MONTGOMERY COUNTY HISTORIC PRESERVATION COMMISSION
STAFF REPORT

Address:	10 Philadelphia Avenue, Takoma Park	Meeting Date:	6/24/2020
Resource:	Contributing Resource Takoma Park Historic District	Report Date:	6/17/2020
Applicant:	Susan Montgomery Rick Vitullo, Architect	Public Notice:	6/10/2020
Review:	HAWP	Tax Credit:	partial
Case Number:	37/03-20II	Staff:	Dan Bruechert
Proposal:	Porch modifications and window replacement

PROPOSAL

FIRST FLOOR PLAN (DEN)
 1/4" = 1'-0"

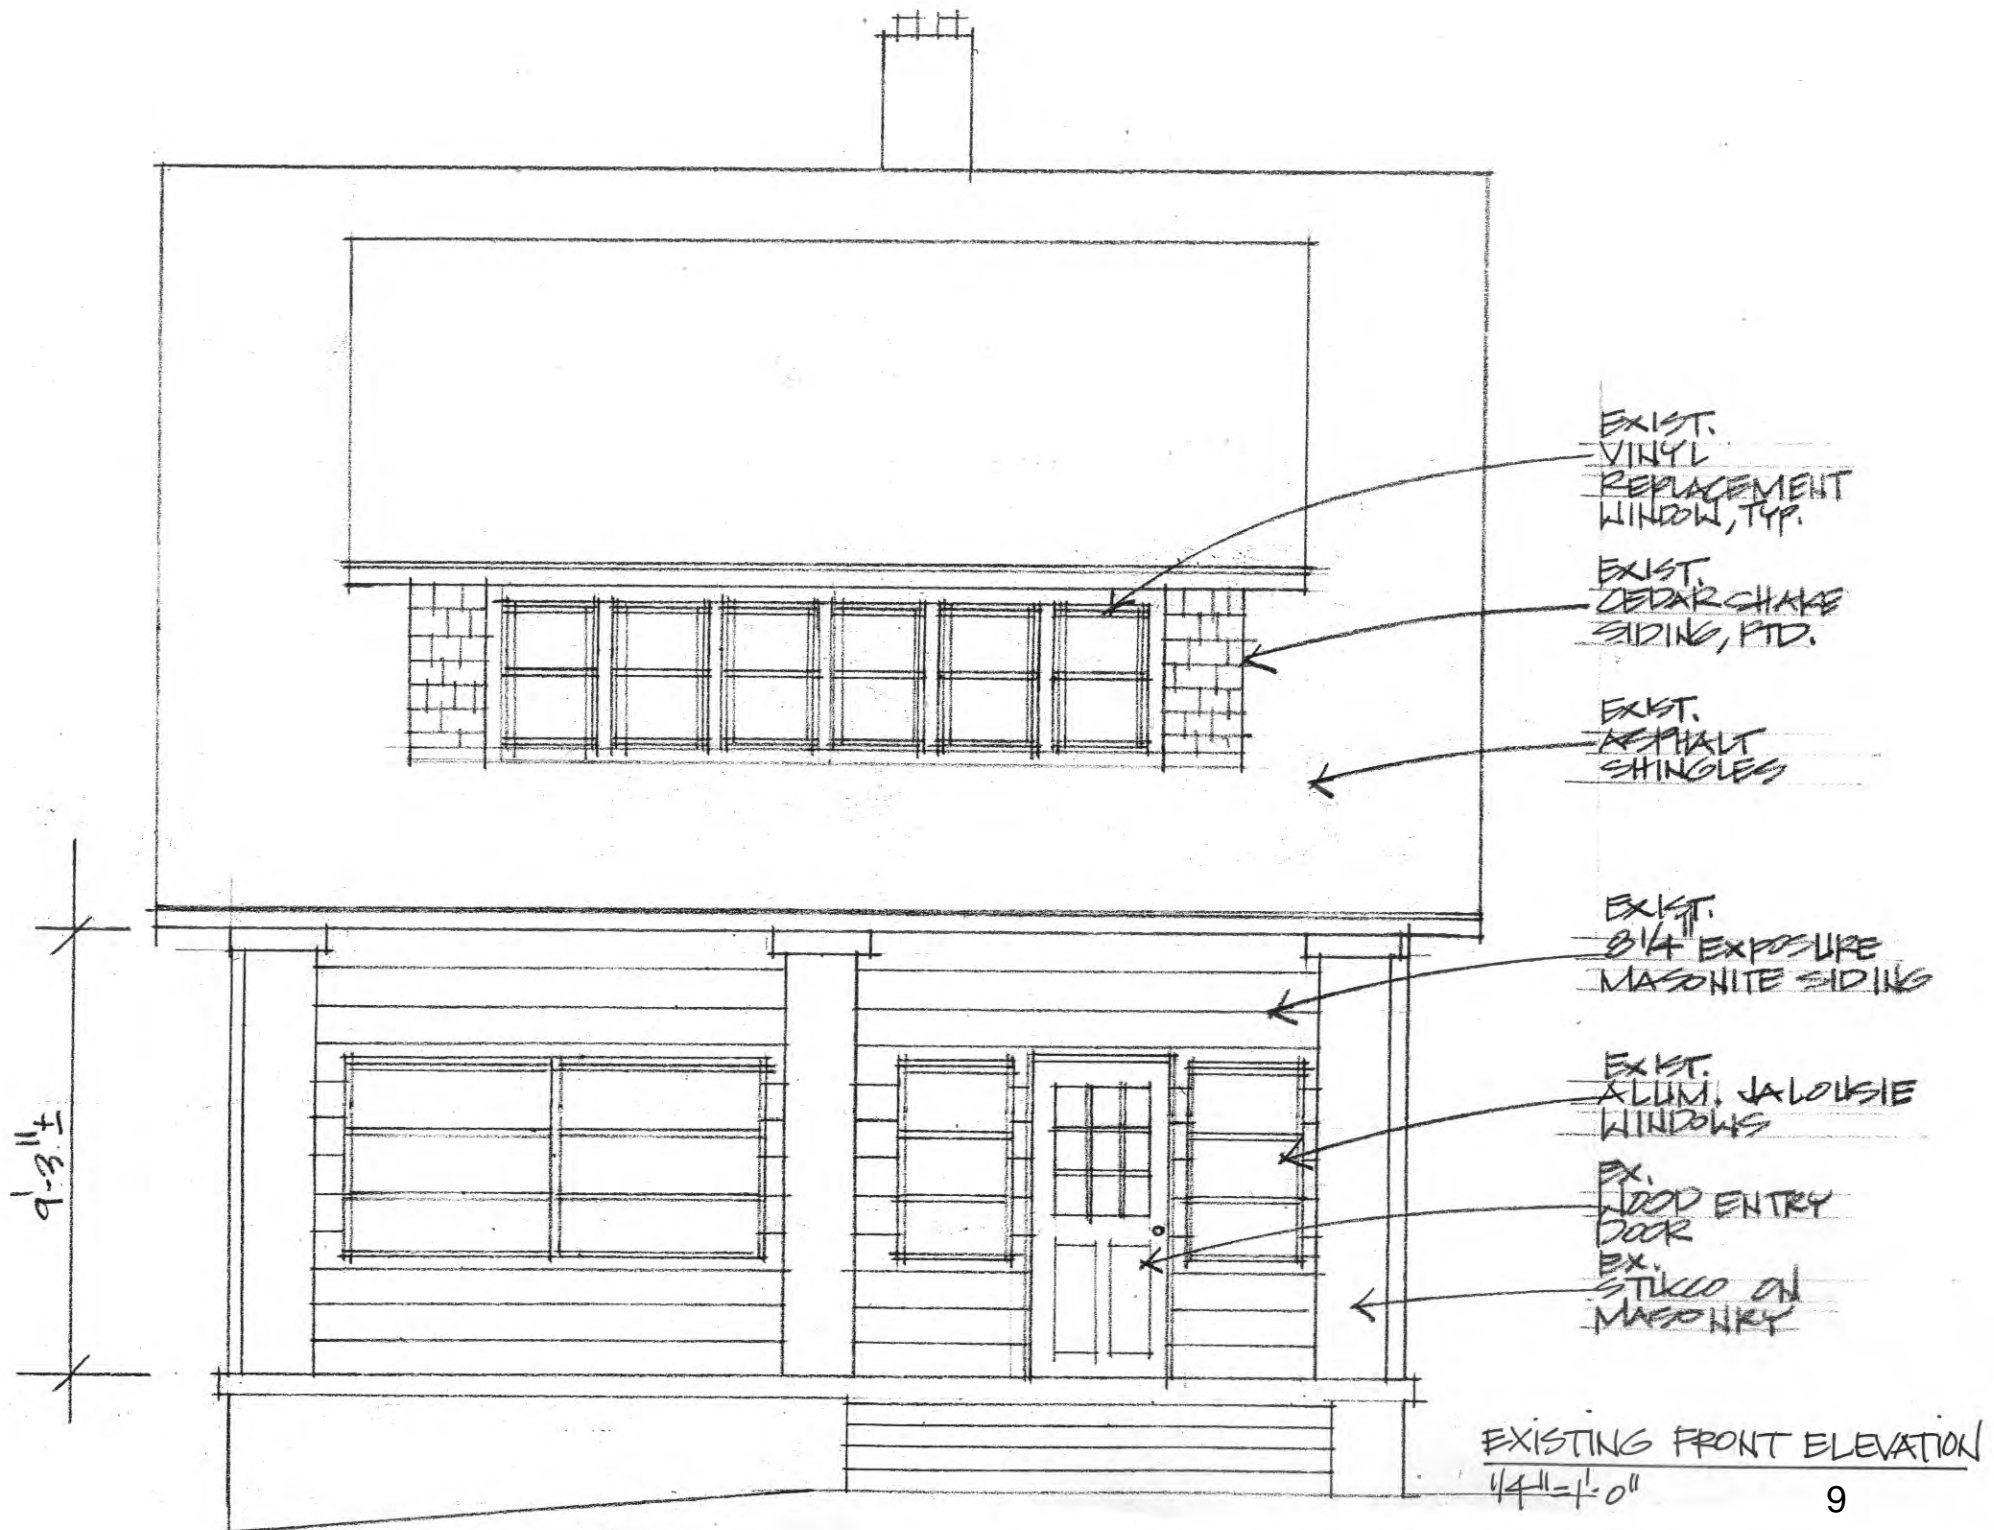
In the right rear corner of the house (south and east elevations), the applicant proposes to replace four one-over-one vinyl sash windows with three-over-one wood windows. These are non-historic windows, so their removal should be approved as a matter of course. While most of the historic wood windows have been removed and replaced with vinyl, there are a few extant examples of three-over-one wood windows. Staff finds that the proposed window is in the correct configuration and material and is appropriate under 24-8(b)(1) and (2), the *Design Guidelines*, and Standards 2 and 5. The window replacement is eligible for the County Historic Preservation Tax Credit as the restoration of a historic feature. Staff recommends the approval of the HAWP.

EXISTING SIDE ELEV. (PARTIAL)
1/4" = 1'0"

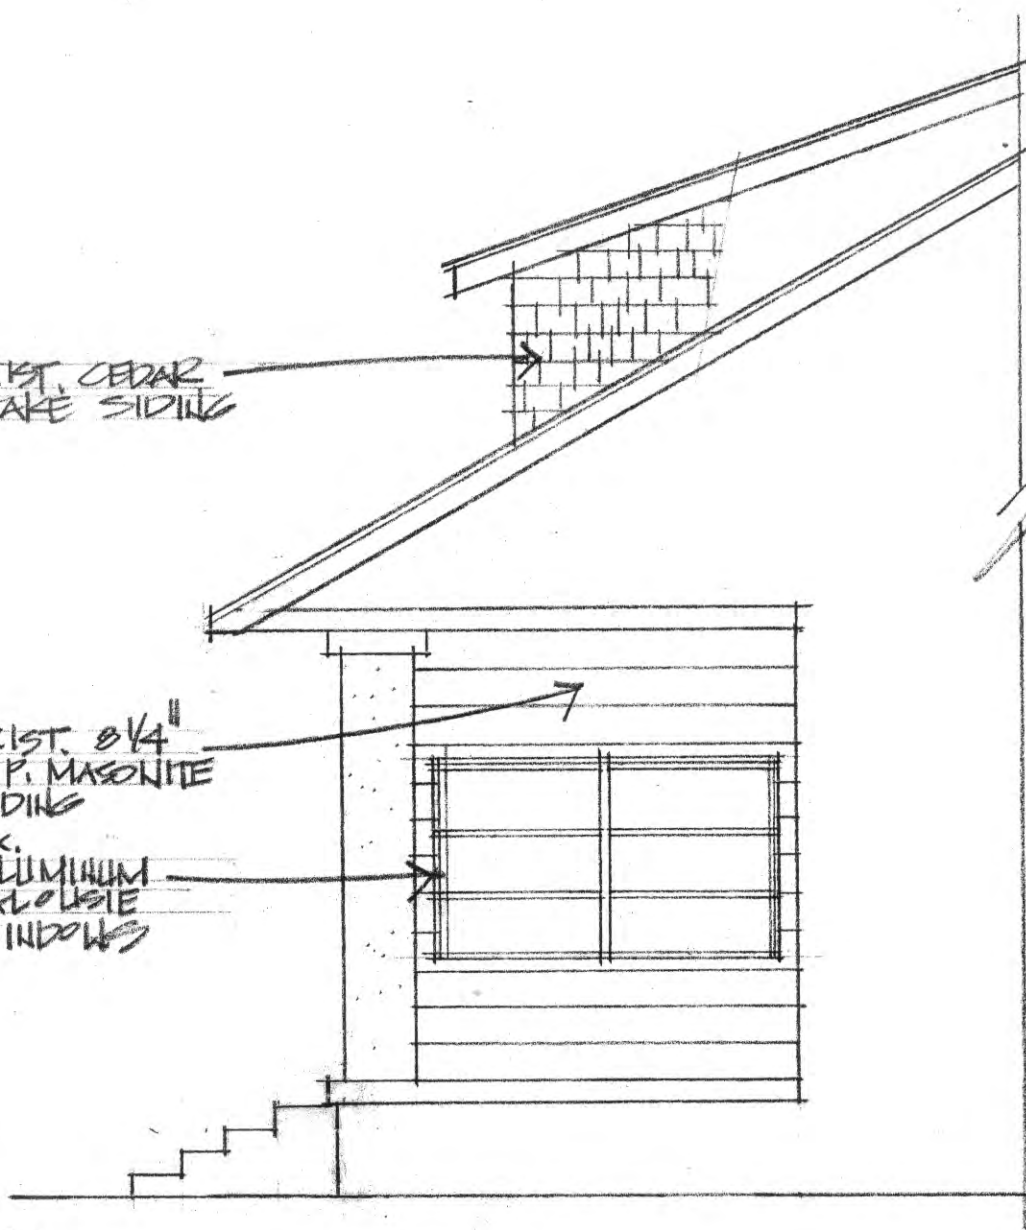
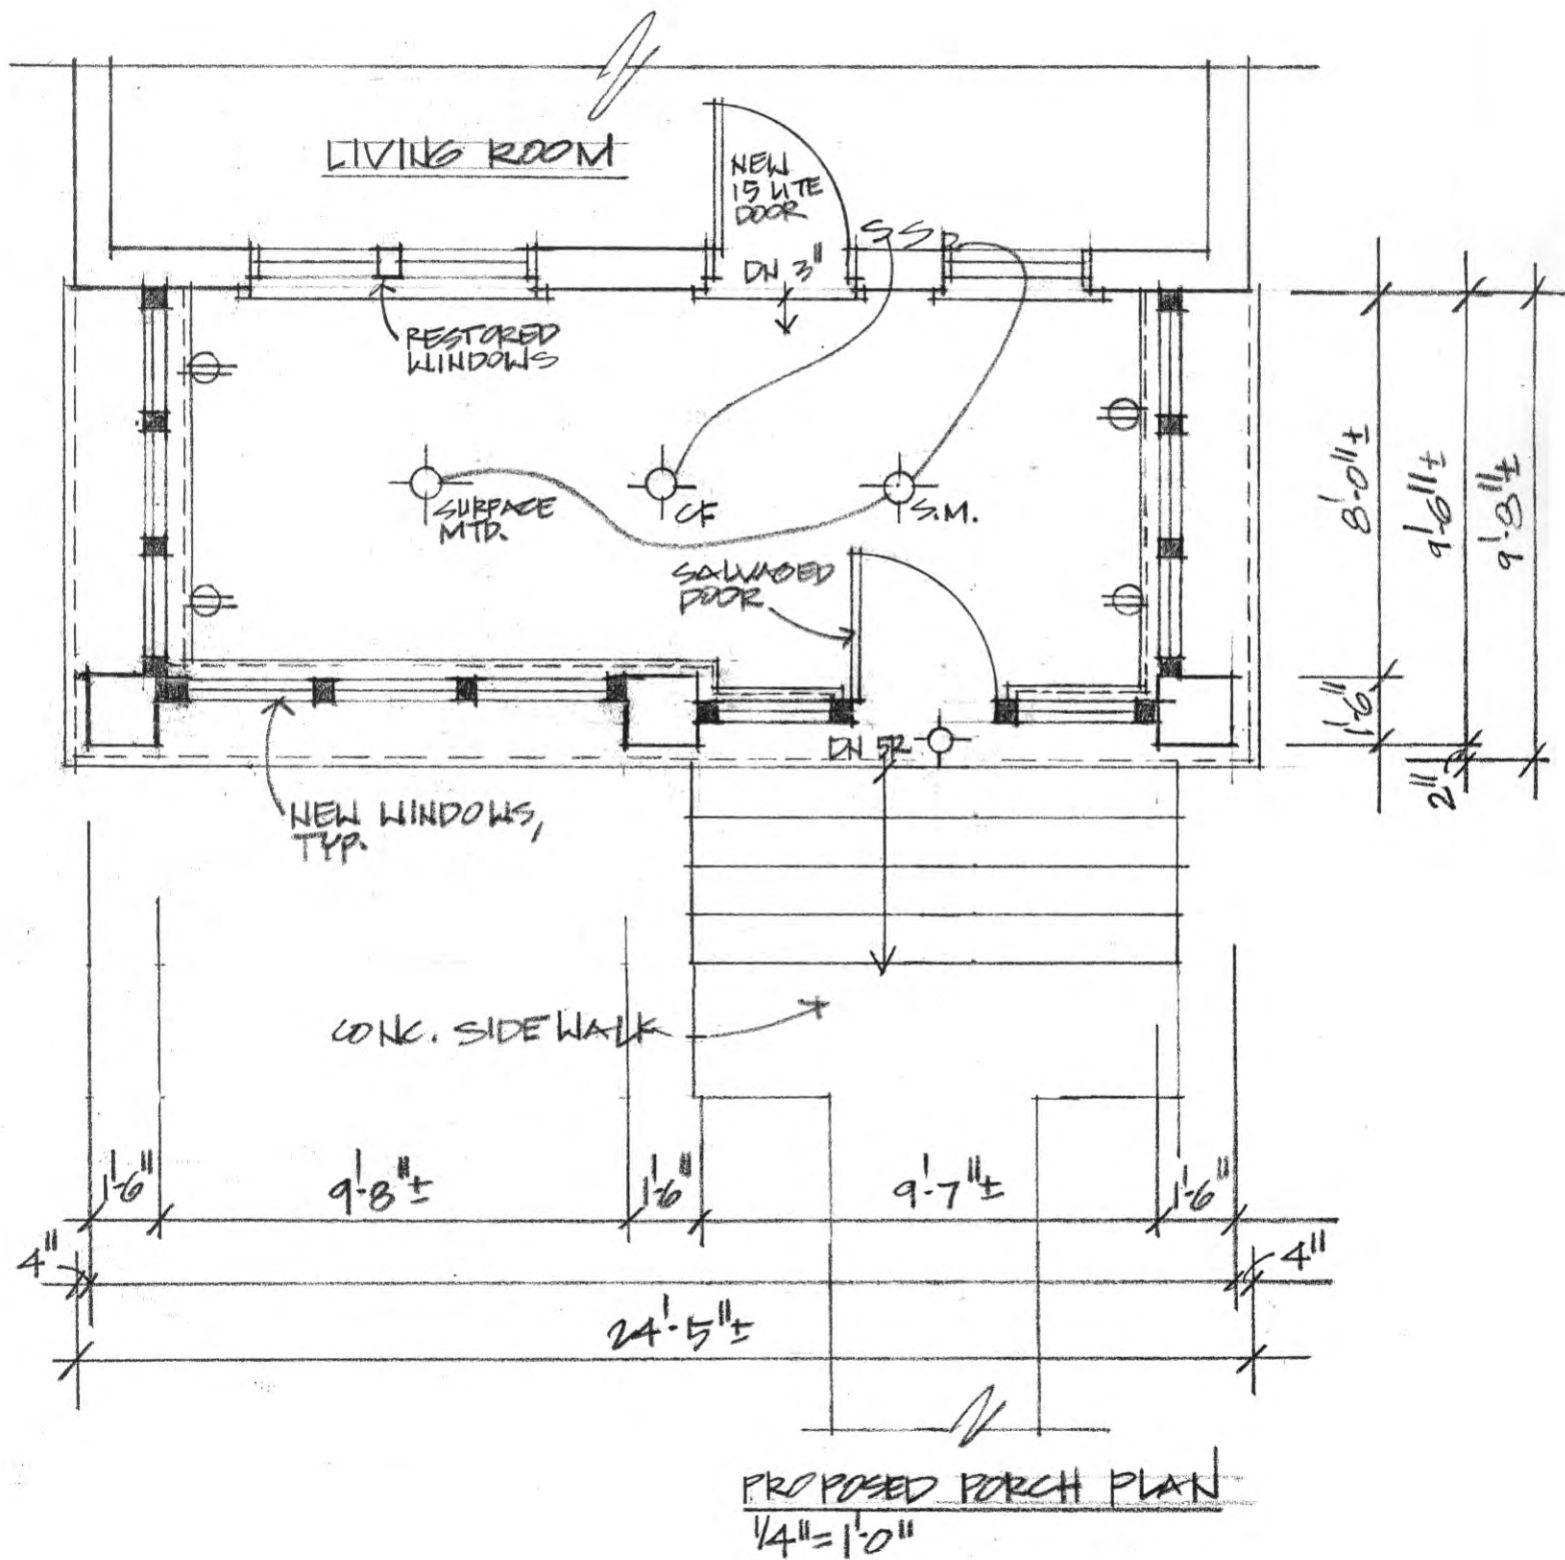
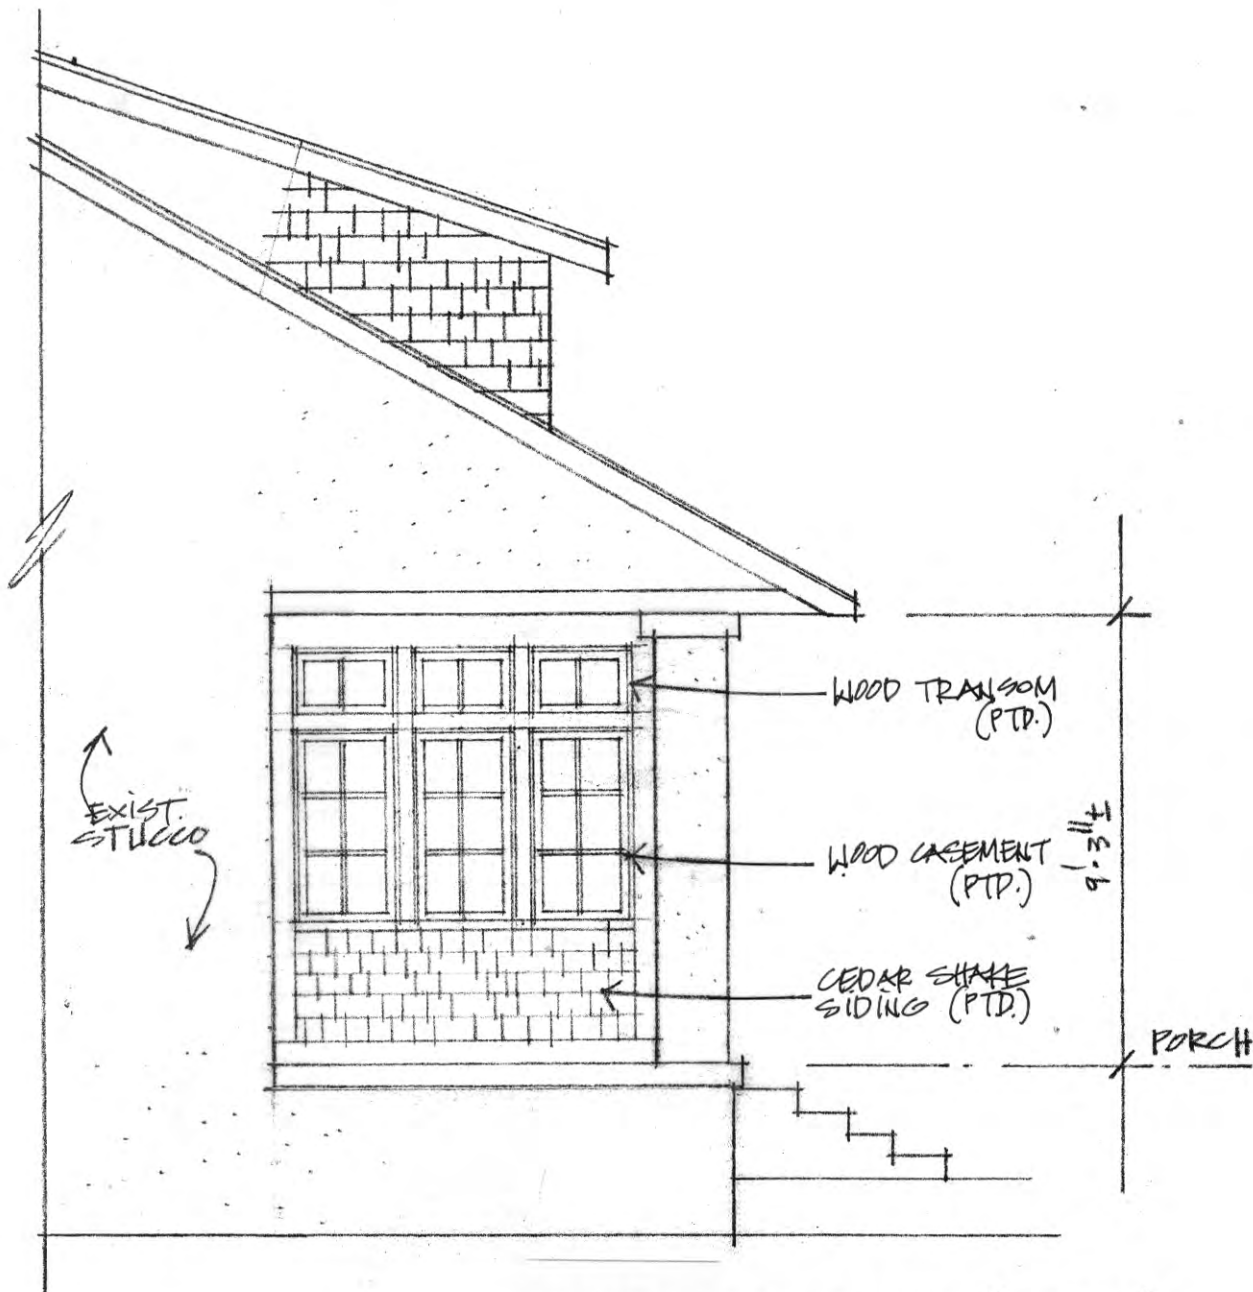
1991. The porch was enclosed with aluminum jalousie windows and Masonite siding, with a contemporary half-lite wood door. Neither the materials nor the configuration is historically compatible and their removal should be supported under 24A-8(b)(1) and the *Design Guidelines*.

In place of the existing enclosure, the applicant proposes to install six-lite wood casement windows with a transom above. Below the windows, the applicant proposes to install cedar shake to match the exterior treatment of the second-floor shed dormer. Finally, the applicant proposes to relocate the historic front door to the exterior of the porch.

Staff finds that a large number of bungalow porches within the Takoma Park Historic District have been enclosed without diminishing the overall character of the District (see the *Design Guidelines*). The proposed work will maintain an enclosed porch, but with compatible materials and in a configuration that is consistent with the style and period of the resource. Additionally, Staff finds that the design of the replacement porch enclosure, with an increase in the amount of glazing and preservation of the stucco porch columns, retains the character of the porch and could be reversed at a future date if desired. Staff finds the porch enclosure is consistent with 24A-8(b)(2) and (d) and the *Design Guidelines*.

Staff recommends that the Commission approve the HAWP application with the condition that the exterior stair railings be constructed out of wood; under the Criteria for Issuance in Chapter 24A-8(b)(1), (2), and (d) having found that the proposal, is consistent with and compatible in character with the purposes of Chapter 24A; the *Takoma Park Historic District Design Guidelines*;
